Senior Planner – Major Assessment
City Development Branch
Council of City of Gold Coast

Objection submission COM/2019/81 -

SARA Approval based on seemingly culpably incorrect information

Attachment A2 - Annotated Third Schedule of Rezoning agreement (Plan 2362-010) showing extractive area is 23.77ha approximately

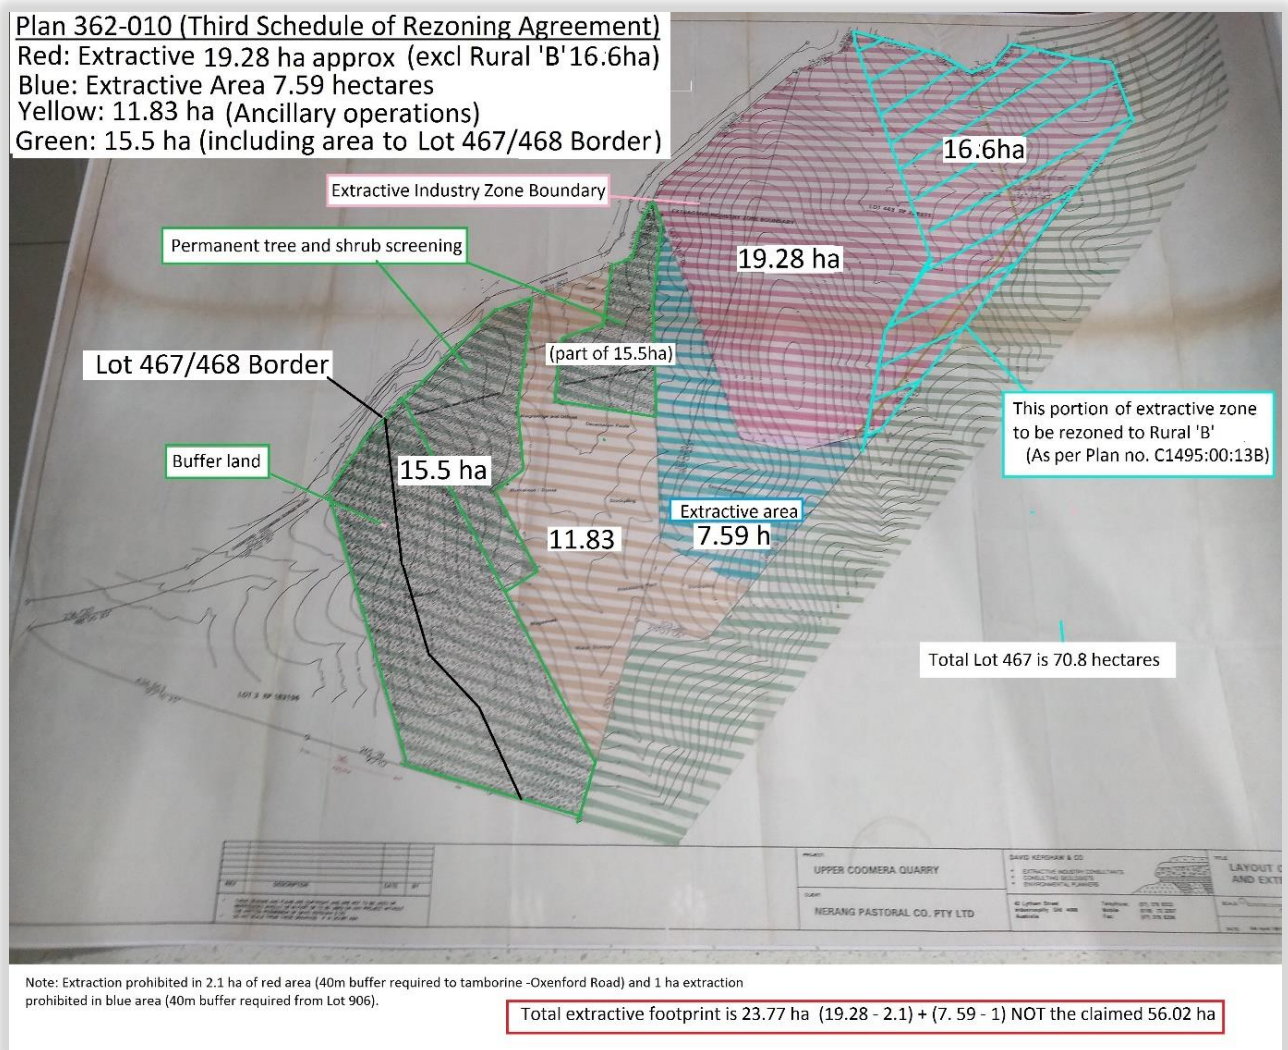
The submitted 'Third Schedule' (Plan 362-010) of the rezoning that was negligently omitted from the development application is reproduced in Attachment A2 (with annotations). It was replaced with a relatively innocuous map that was in fact the Fourth Schedule with the title 'FOURTH SCHEDULE' removed (Attachment A3). The original copy is shown in Attachment A4. This would seem a fraudulent misdirection.

I believe SARA approval was also based on the mistaken believe that an area of 15.5 hectares the southwest and west (labelled as “Buffer land” and “Permanent tree and shrub screening” on the missing Third Schedule, reproduced in Attachment A2) were also part of the extractive area and not designated buffer areas for the life of the quarry.

Note title "FOURTH SCHEDULE" has been removed. Original shown in Attachment A5 below.

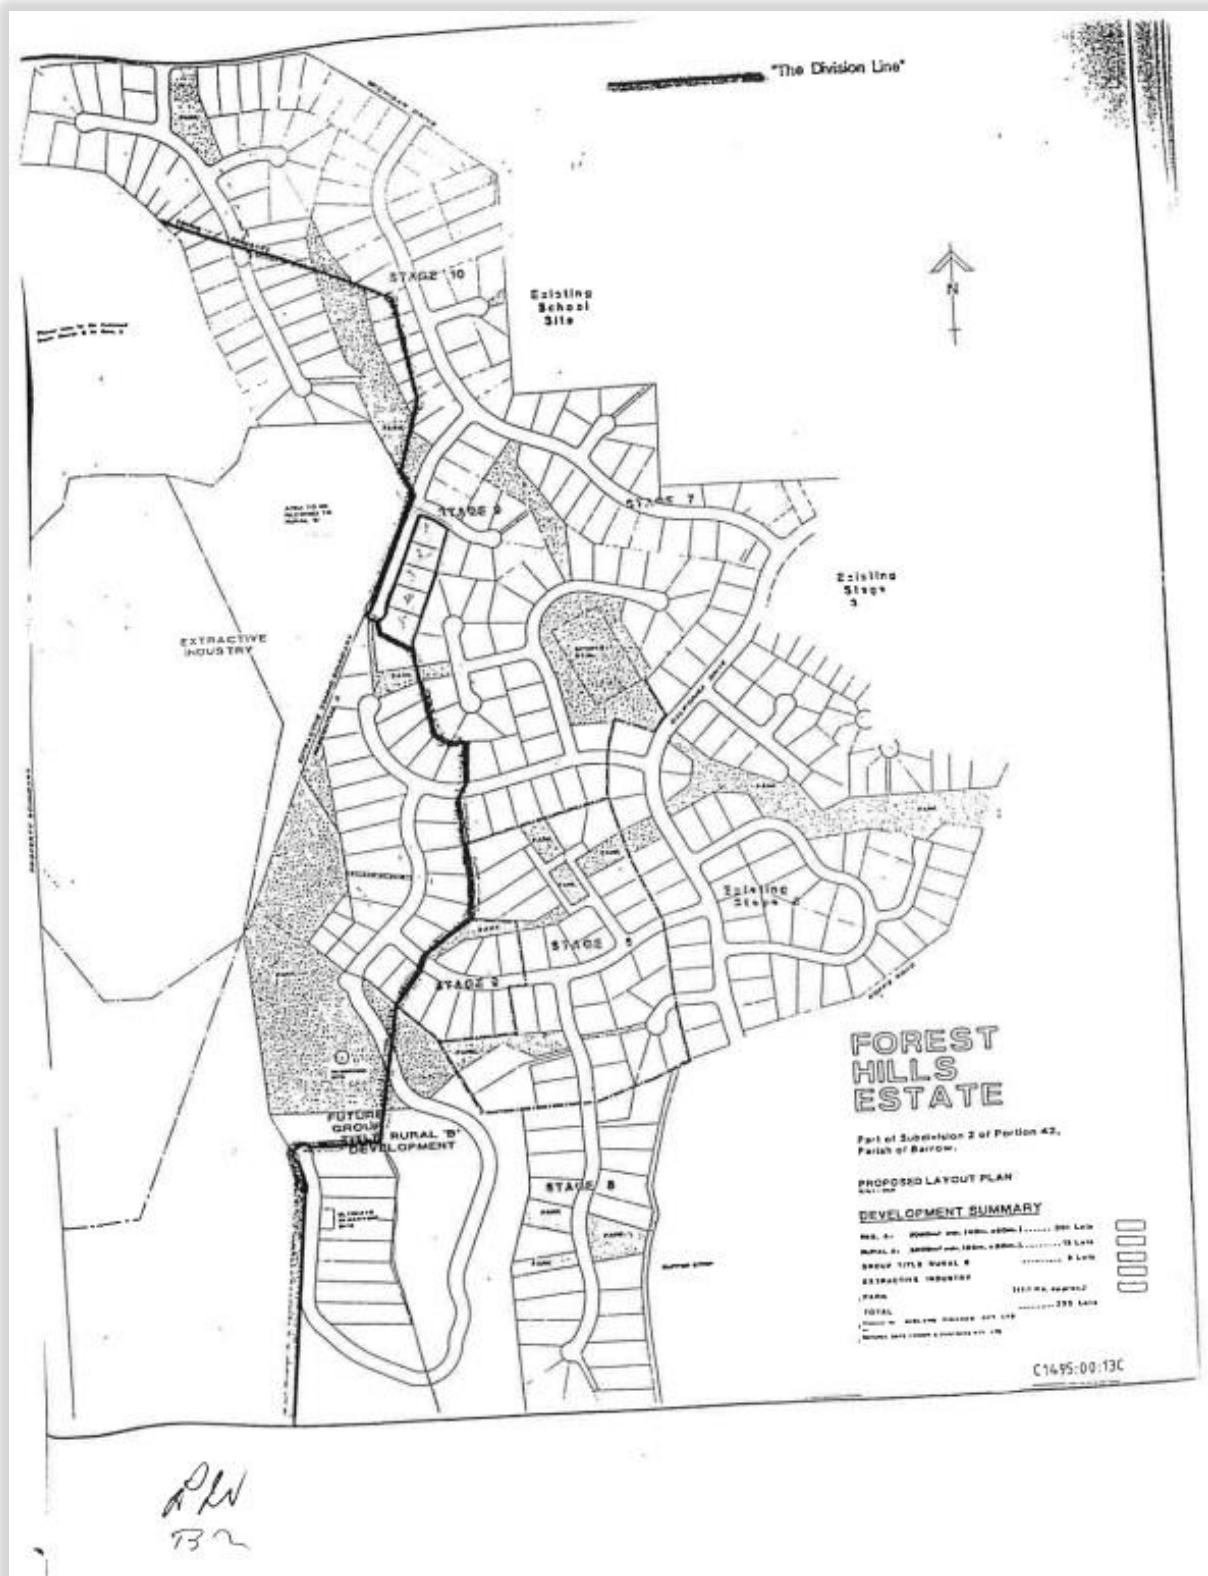
(Note the judge in this case indicated the Rural 'B' is an area of 10.5 hectares. However, I believe this is incorrect assumption and this is based on the smaller area identified in Attachment A3 identifying an earlier extractive footprint. The Rural 'B' area was subsequently defined as a result of the David Kershaw report, who was a geologist, who attempted to establish relative harmony between the proposed residential development to the east and the quarry to the west, the result is clearly shown in Attachments B1, B2 and B3) which is approximately 16.6 hectares).

Attachment A4 - Original version of Fourth Schedule of Rezoning agreement

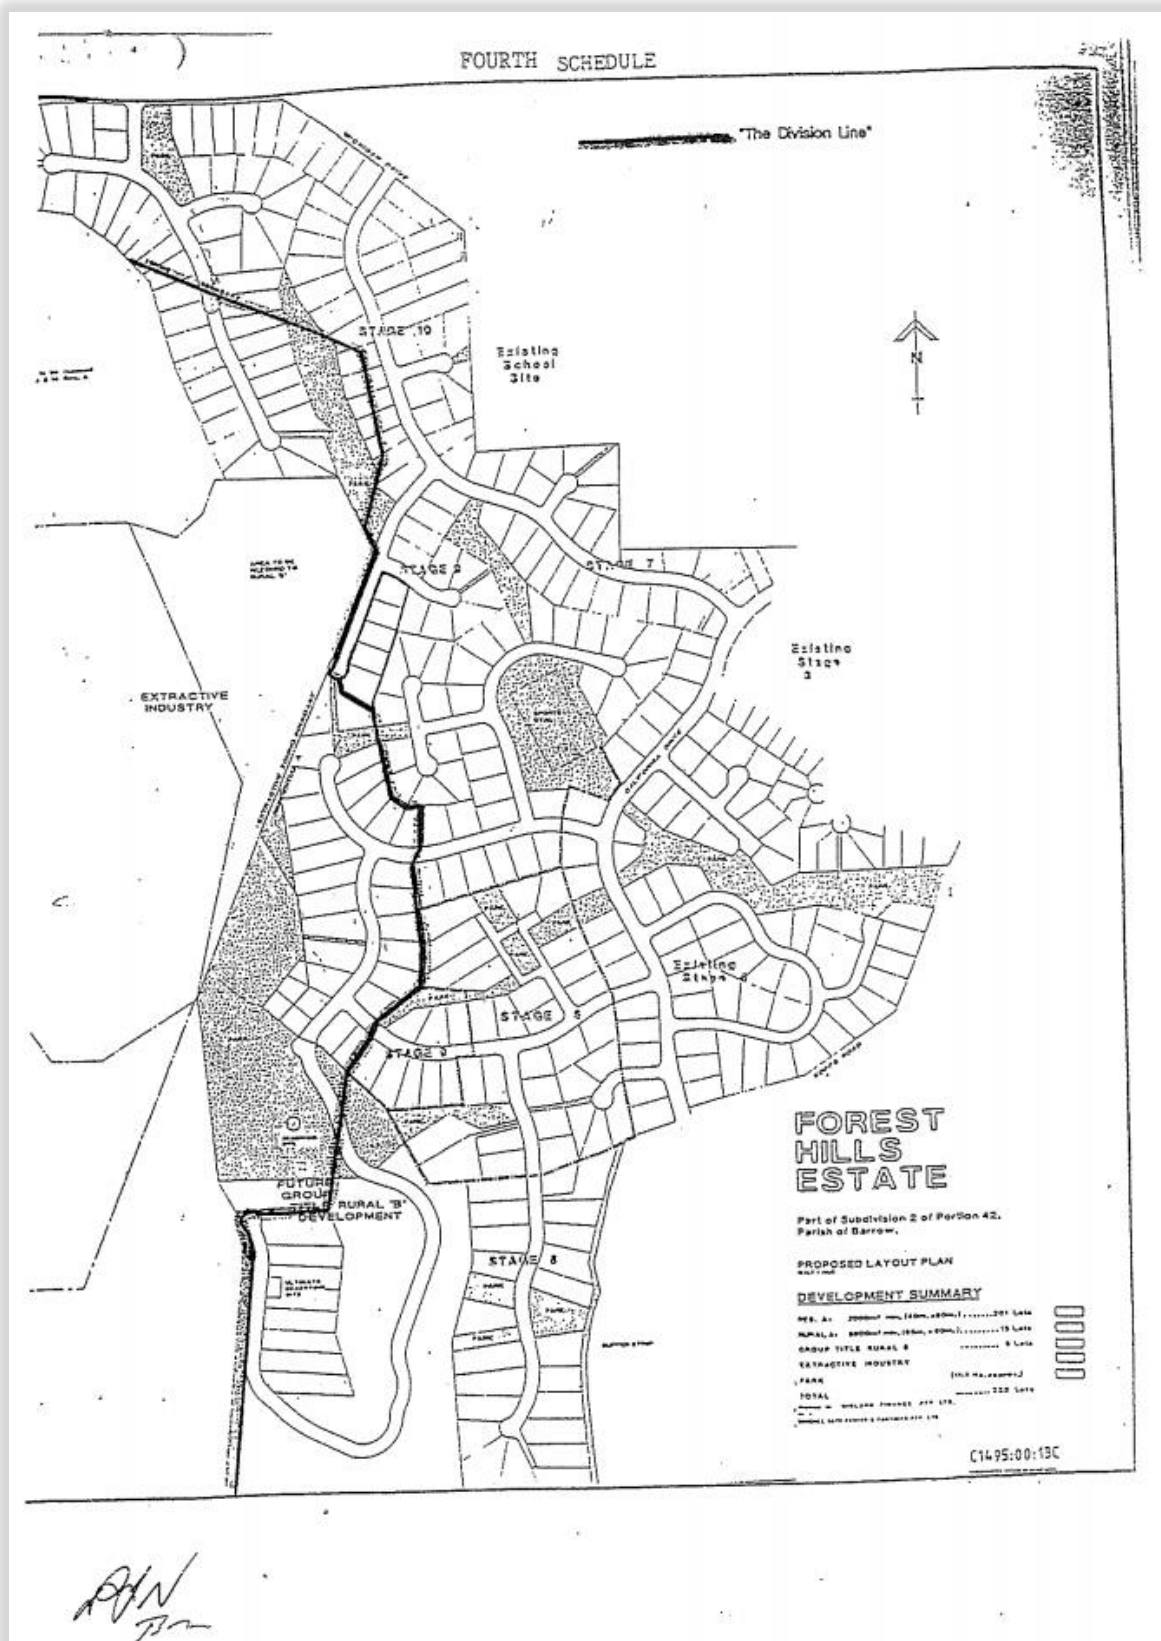
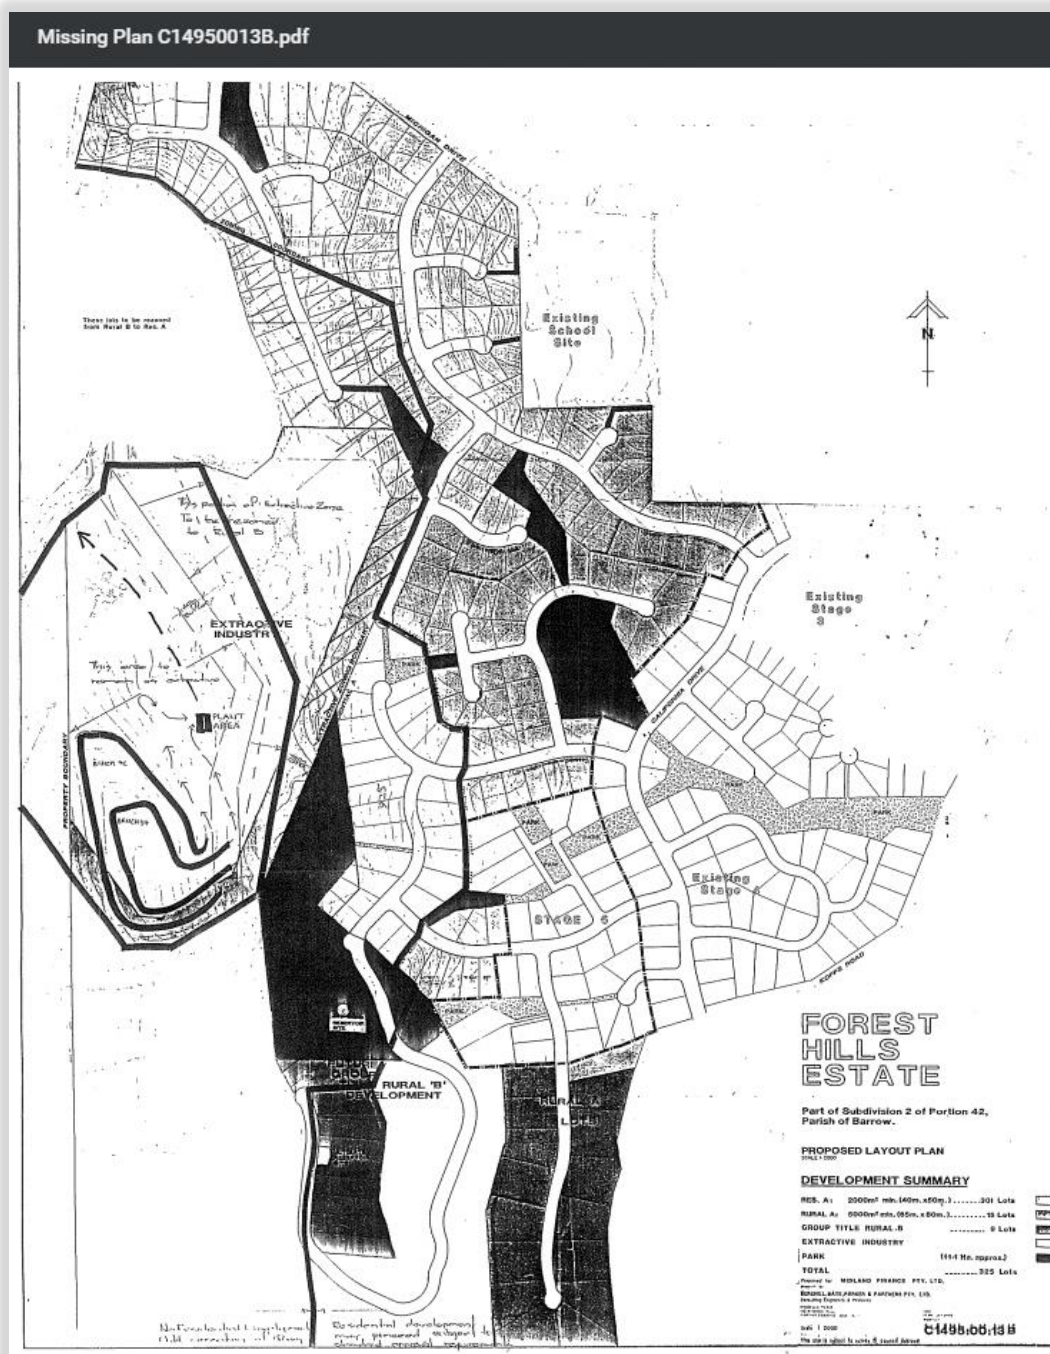
(note title: "FOURTH SCHEDULE" has not been removed in correct version)

Attachment B2 - Plan C1495:00:13B (Showing close-up of Rural 'B' area)

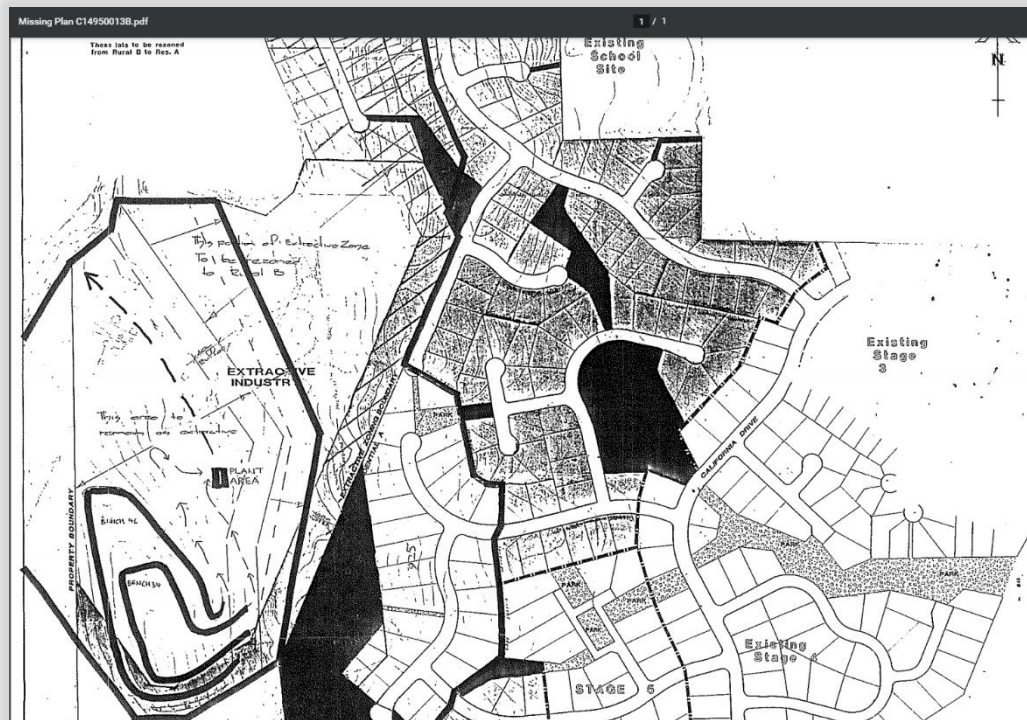
Approximately 16.6 hectares of area to the north and northeast should have been Rezoned by the applicant as Rural 'B' (as shown in Attachment A2). The status of this area of land is verified in 'Plan C1495:00:13B', an inherent part of their current approval but negligently, in my opinion, also omitted from the development application. The Rural 'B' area is labelled on this document as: *"The Portion of Extractive Zone to be rezoned as Rural 'B' "* (reproduced in Attachment B1). This is shown in close-up in attachment B2 and annotated in B3 for clarity. Unfortunately, the applicant failed to rezone this area as promised. However, despite the apparent negligent actions of the applicant, the clear intent of this remains in force.

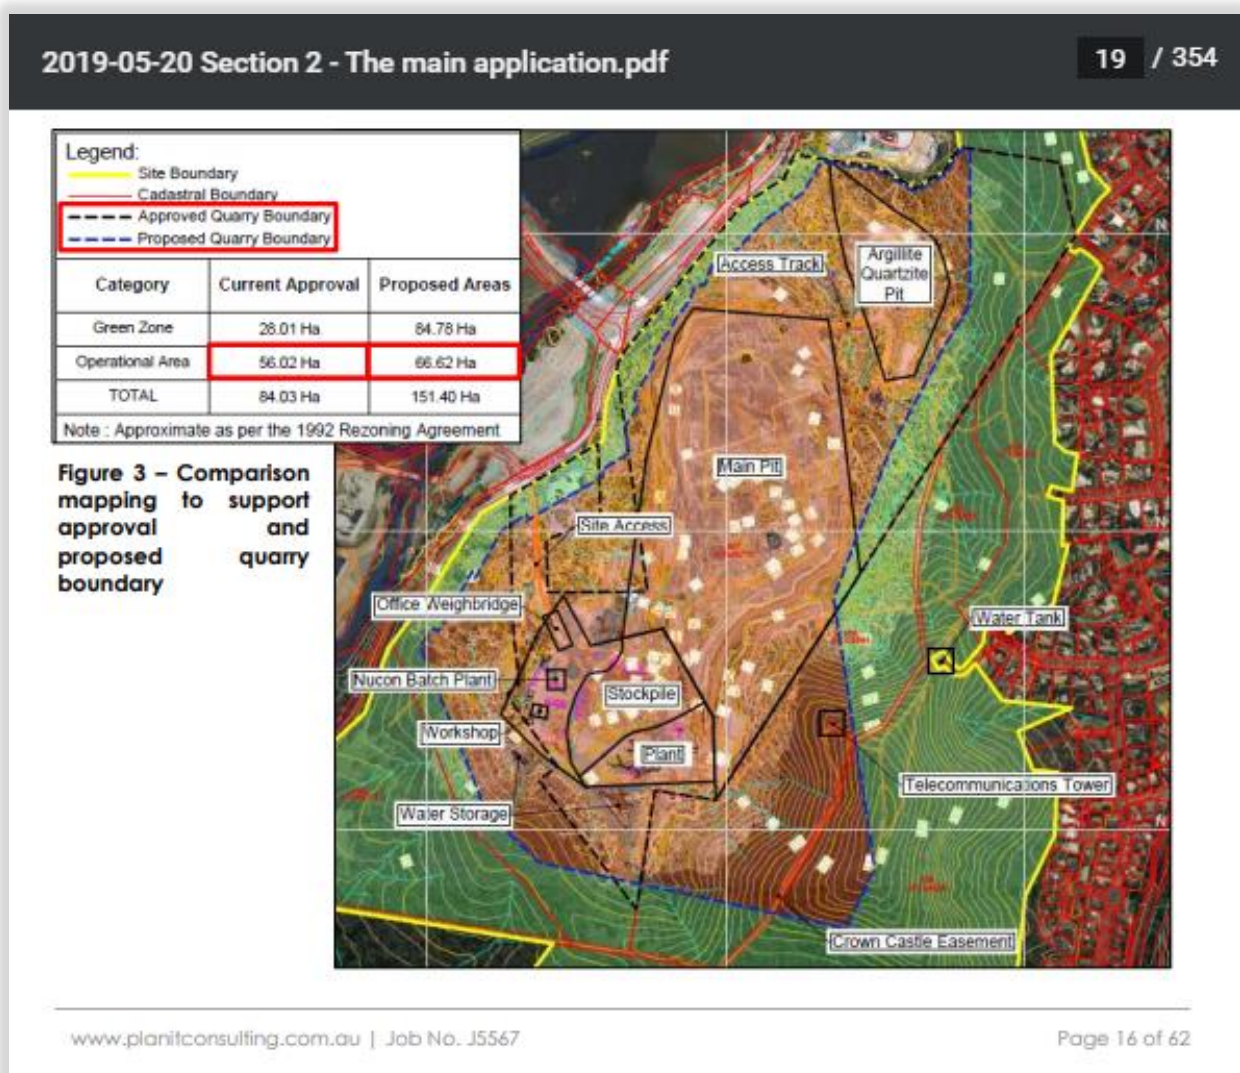
It is particularly sad to see that in the Main application the applicant sought to exchange an area of this protected Rural 'B' land that it claims as extractive area in exchange for more lucrative land in the southeast and southwest (Attachment C1).

The map of the area, reproduced in attachment C2, taken from the Main application, shows the claimed approved quarry footprint includes all the Rural 'B' area with no reference made to it.

In fact, the applicant incongruously claims that this DA is highly beneficial for the native fauna and local wildlife and the local residents in the north east by releasing the area in the northeast in exchange for areas in the southeast and southwest (Attachment C3). However, it would seem abundantly clear, this northeast area is not negotiable as it is a part of the Rural 'B' protected area and is thus not part of the extractive footprint and therefore the 'claimed' approved footprint in Attachment C2 is, in my opinion, highly and culpably incorrect and thoroughly misleading.
